THE GRANGE AT LINDEN DESIGN REVIEW BOARD

12.05.2016

DPD PROJECT # 3020289

DESCRIPTION:
7 STORY ASSISTED LIVING RESIDENTIAL FACILITY
109 UNITS, 114 BEDS
46 PARKING STALLS

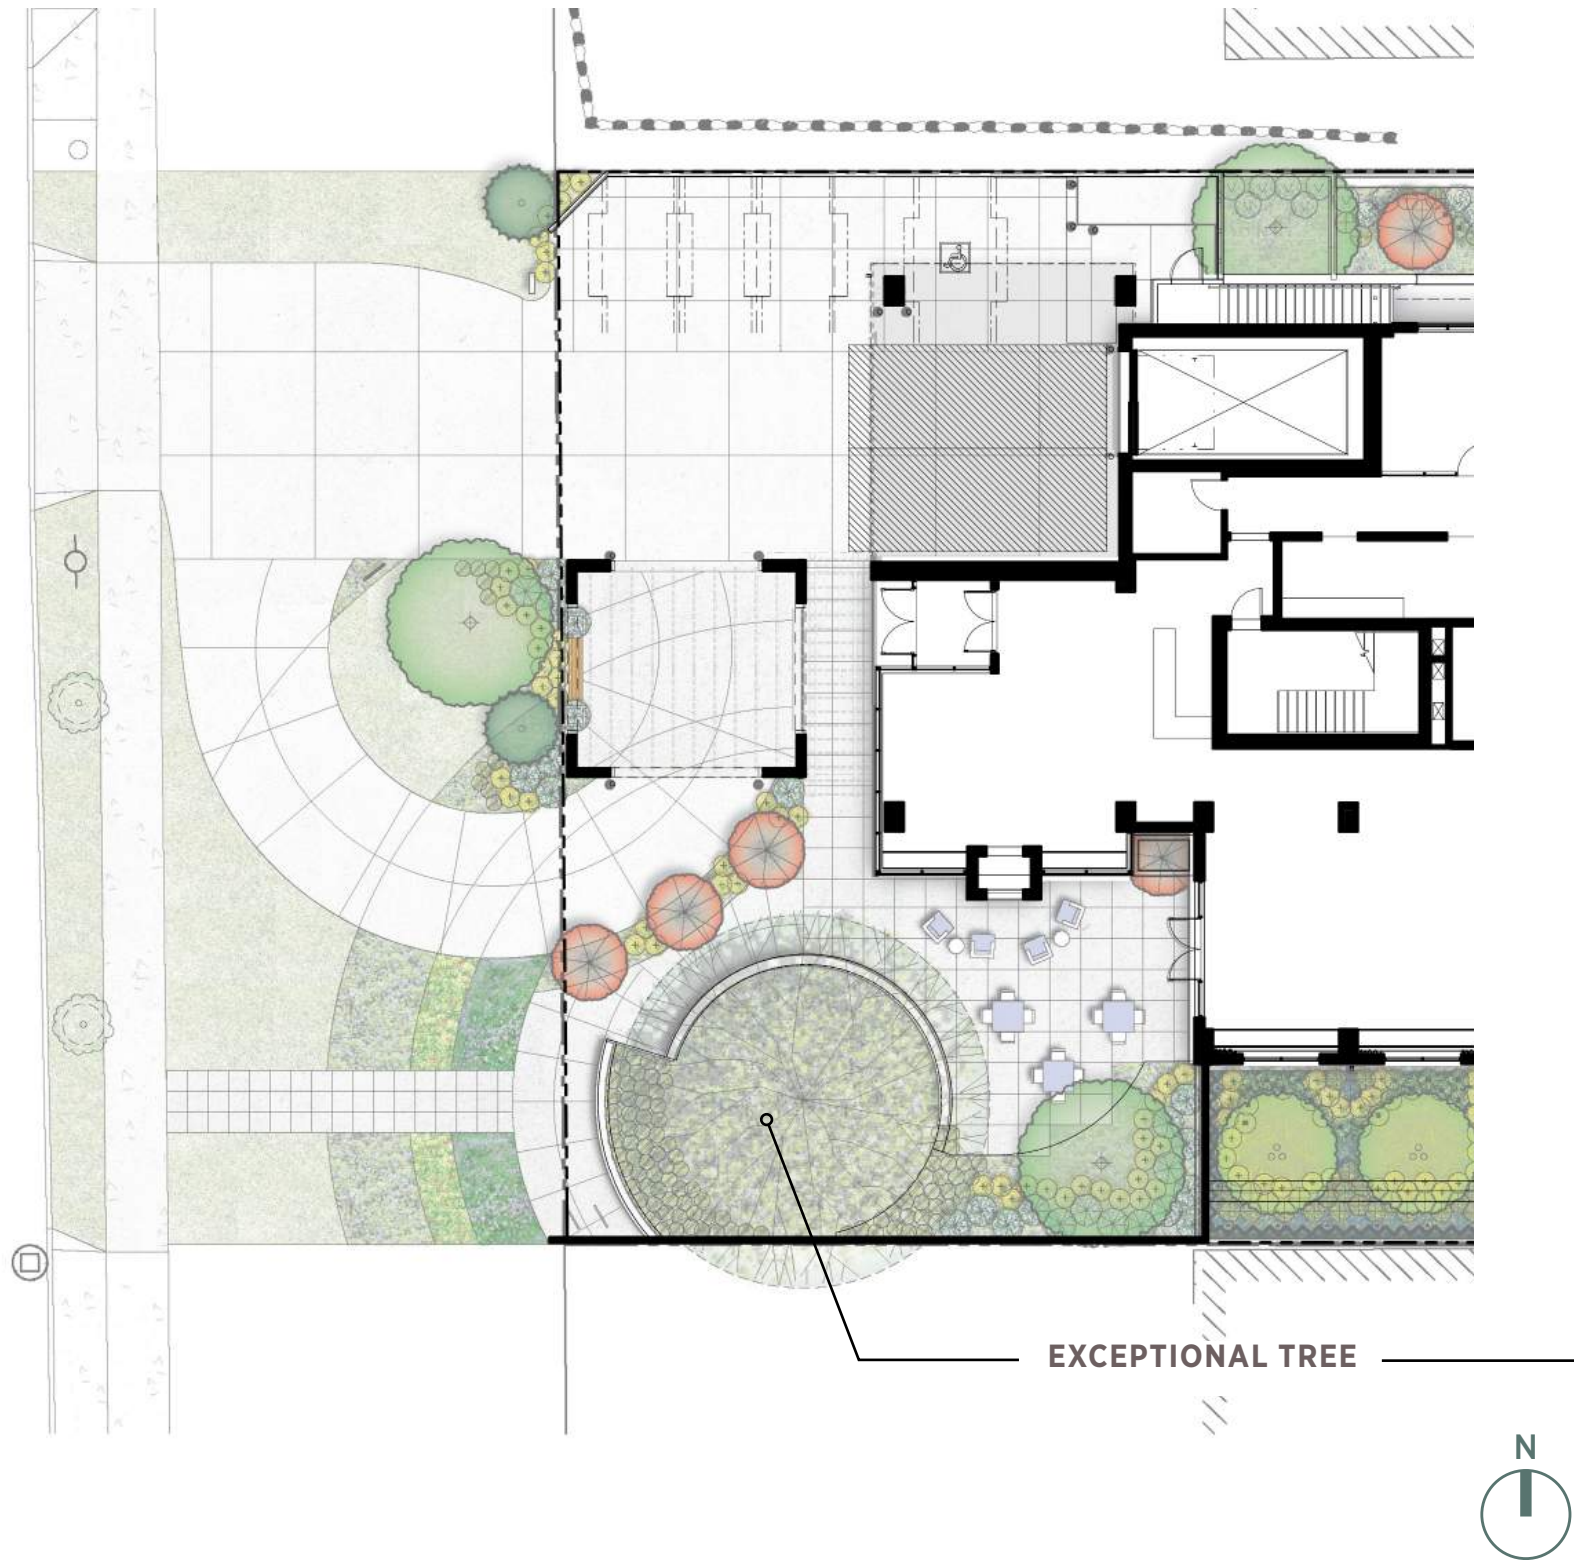
"For the next meeting, the applicant must demonstrate why the preferred massing option, with removal of the exceptional tree, is the best design solution. (DC2-A-1)"

The removal of the exceptional tree hinders rather than enhances the integrity of the site. In the proposed design the exceptional tree is maintained, helping to strengthen the overall massing and concept of the building. Every opportunity has been taken to celebrate the tree. It is the landscape focal point from the lobby and the activity lounge at level 1. An outdoor seating area beneath the tree is enhanced with an outdoor fireplace and built in benches.
